## Community Development Code Chapter 58

### 58.010 PURPOSE

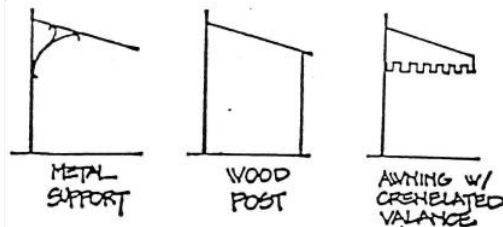
**Commented [FJ10]:** For clarity staff recommends this term be defined. A preliminary definition might include the following:

Western false front architecture was intended to create visual continuity and a prosperous urban atmosphere during the early settlement period of western towns. Defining characteristics include:

- The street facing façade(s) rises to form a parapet (upper wall) which hides most or nearly all of the roof;
- The roof is almost always a front gable, though gambrel and bowed roofs are occasionally found;
- A better grade of materials is often used on the street facing façade than on the sides or rear of the building; and
- The street facing façade(s) may exhibit greater ornamentation than other sides of the building.

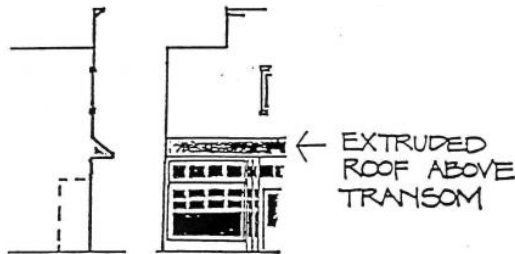
**Commented [WD15]:** West Linn Public Works Dept. does not want permanent fixtures in the right-of-way as numerous utilities run under the sidewalk. Access is complicated by structural elements such as posts.

**Commented [FJ16R15]:** On May 19, 2020 the HRB had questions regarding the repair and remodel of existing structures with wood posts. Does this code change make them nonconforming and/or require them to remove the posts? Planning staff is still coordinating with Public Works on this issue.

**Commented [FJ17]:** The middle graphic may need to be removed if posts are prohibited in all situations.

**Commented [FJ18]:** On May 19, 2020 the HRB requested a minimum canopy depth to provide a clear and consistent standard that won't be subject to continual reinterpretation. There was also discussion of language requiring consistency between new canopies and adjacent existing canopies to reference and establish streetscape continuity.

**Commented [WD19]:** With the new 12 foot sidewalks, the recommendation is to allow awnings that only cover a portion of the sidewalk as no posts will be allowed for support. Staff recommends removing the specific height requirement and state must meet ADA.

Planning staff to survey the standards used by other jurisdictions before proposing new language for HRB consideration.
